MEMORANDUM

REVIEW TYPE: Preliminary Plan Review

PROJECT NAME: 4901 Hampden Lane

CASE #: 120070280

PRELIMINARY PLAN
LOT 35, BLOCK 24B
4901 HAMPDEN LANE
7TH ELECTION DISTRICT - MONTGOMERY COUNTY - MARYLAND

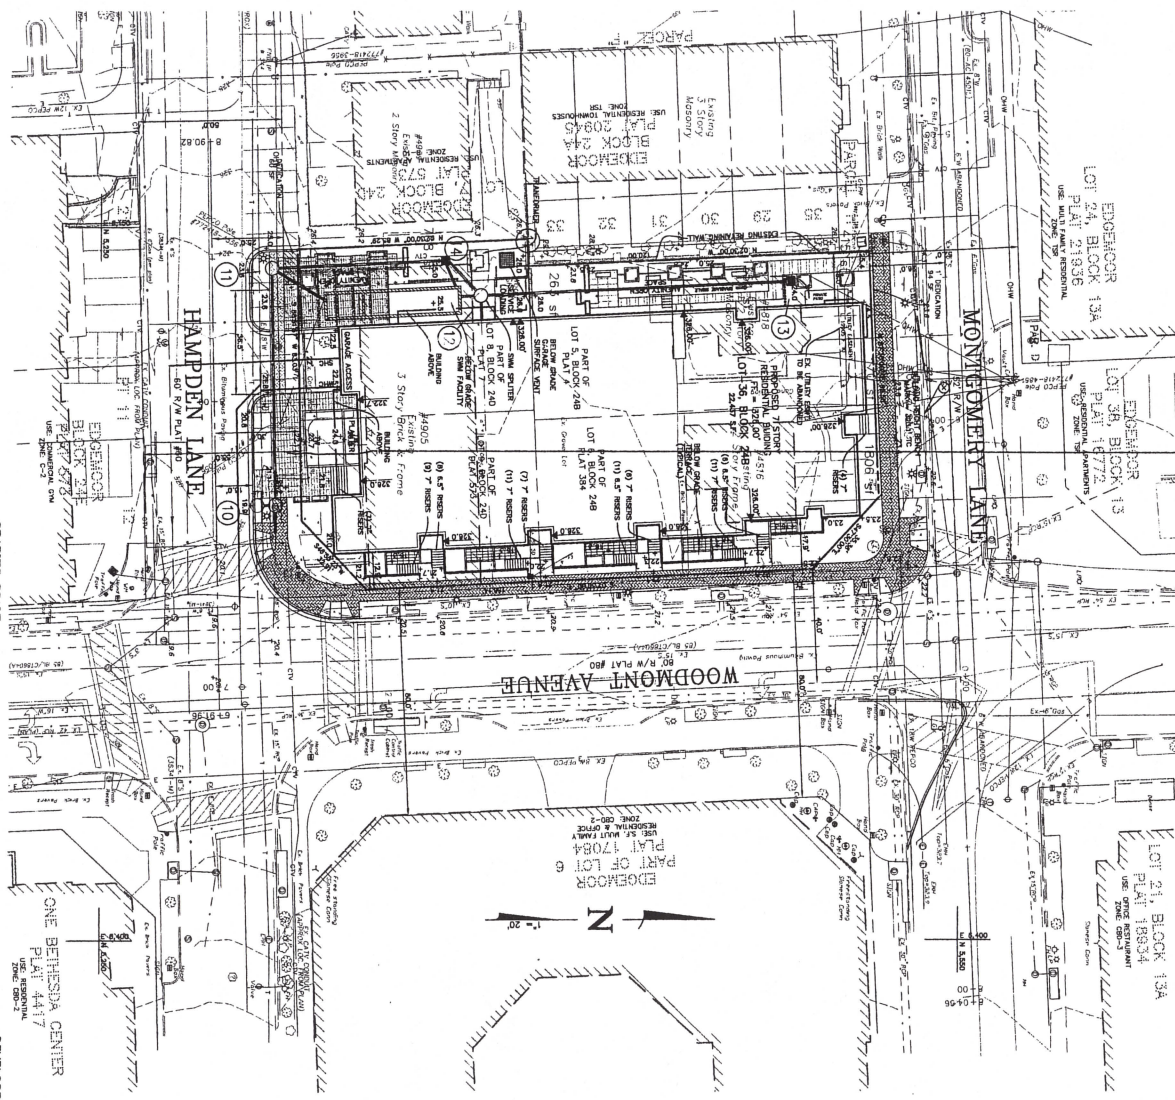
- c. The certification and builder acceptance letter must be provided to MNCPPC Environmental Planning staff before building permits are approved.
- 5) The Applicant must modify the preliminary plan prior to certification, to show the following ADA-compliant pedestrian accommodations:

- a. The crosswalk must be perpendicular to the curb across Hampden Lane's western leg at the intersection with Woodmont Avenue.
 - b. Show on the plan the receiving handicapped ramps on the east side of Hampden Lane and the north side of Montgomery Lane. If they do not exist, provide them.
